Observation Community Club

Accessibility Review

Transition Plan - (location/priority)

City of Duluth, MN

Photo 1: There is not currently an accessible route to the building entry.

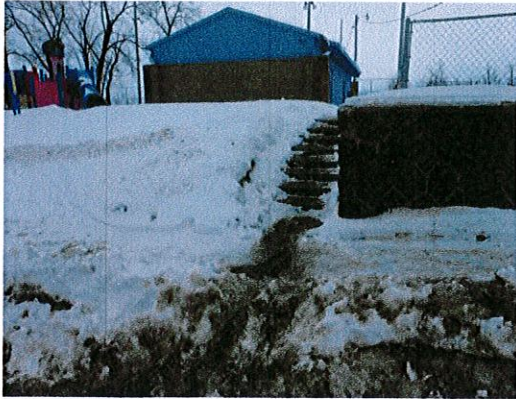
Location JQP # / Item #	Solution / Comments	Qty	Unit Cost	Total Cost	Priority	Estimated Compl. Date	Person Responsible	Actual Compl. Date	Actual Cost
Main Entry									
08A 16343	Provide an accessible route. IBC 1104 <i>There are 8 exterior stairs up from the sidewalk/street. Photo 1.</i>	1	\$20,000	\$20,000	2				
12B1 16345	Extend sidewalk to provide appropriate maneuvering clearance on the latch side of the door. ICC / ANSI 404.2.3.1 <i>Photo 2.</i>	1	\$500	\$500	2				
				<i>Location Subtotal:</i>					\$20,500
									Priority # 2 Total \$20,500

Photo 2: Replace the concrete stoop to eliminate the rise at the threshold, enlarge to provide maneuvering clearance and eliminate the slope at the entry.

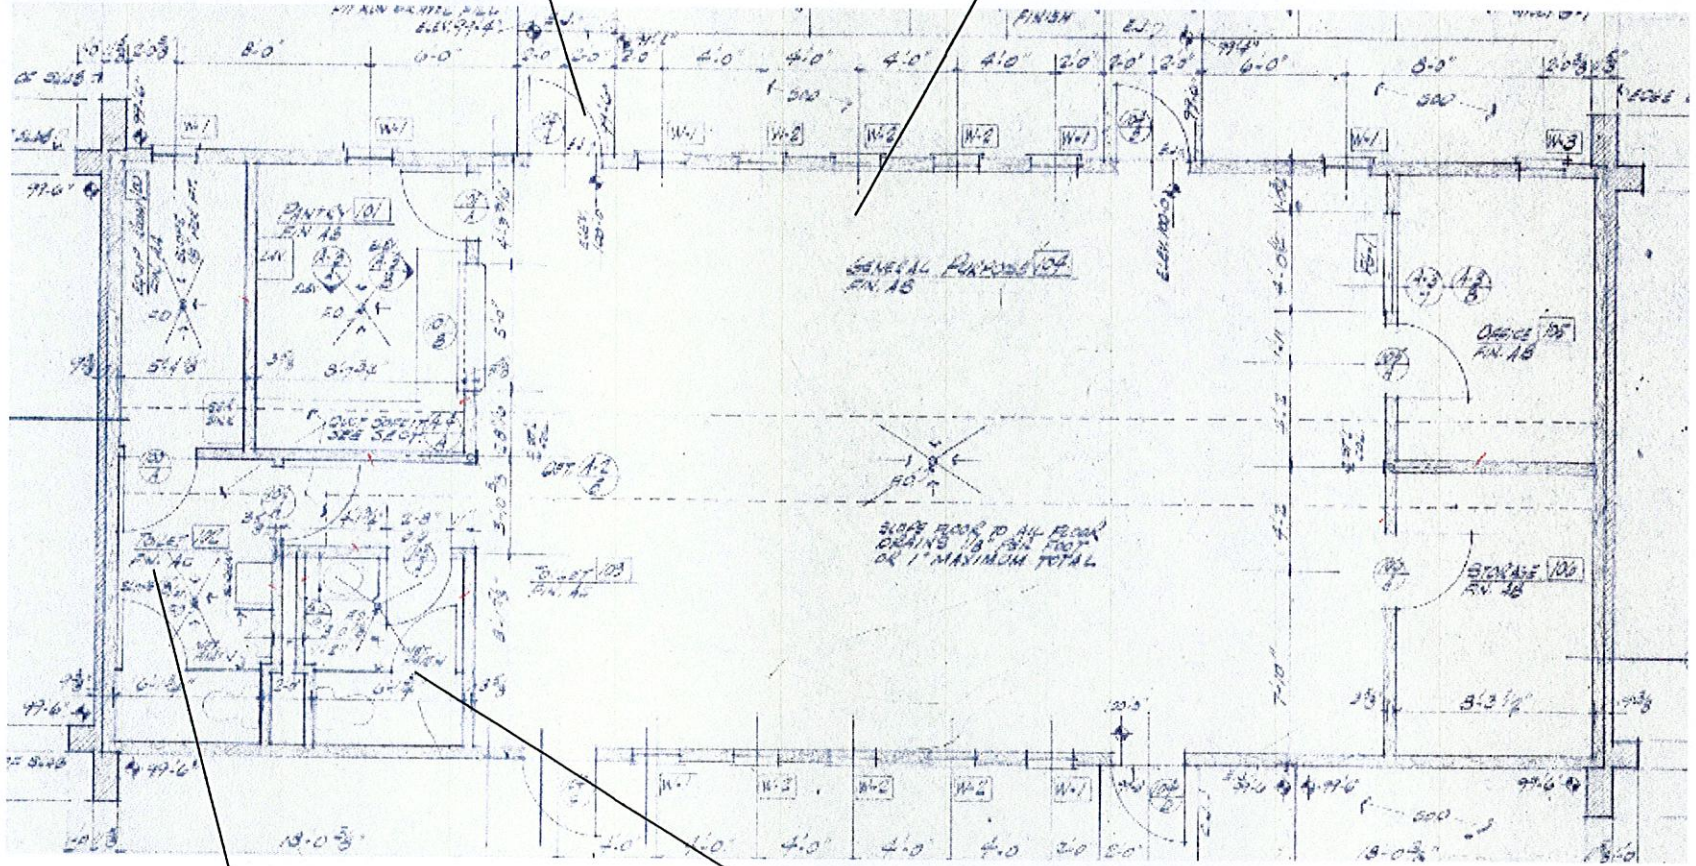
Create an accessible route from the street
 Extend sidewalk to provide maneuvering clearance
 Bevel rise at threshold

Relocate boxing ring to provide 36" clear route

Add raised and braille sign

Add raised and braille sign
 Remove interior partitions and made single user
 Insulate pipes at lavatory
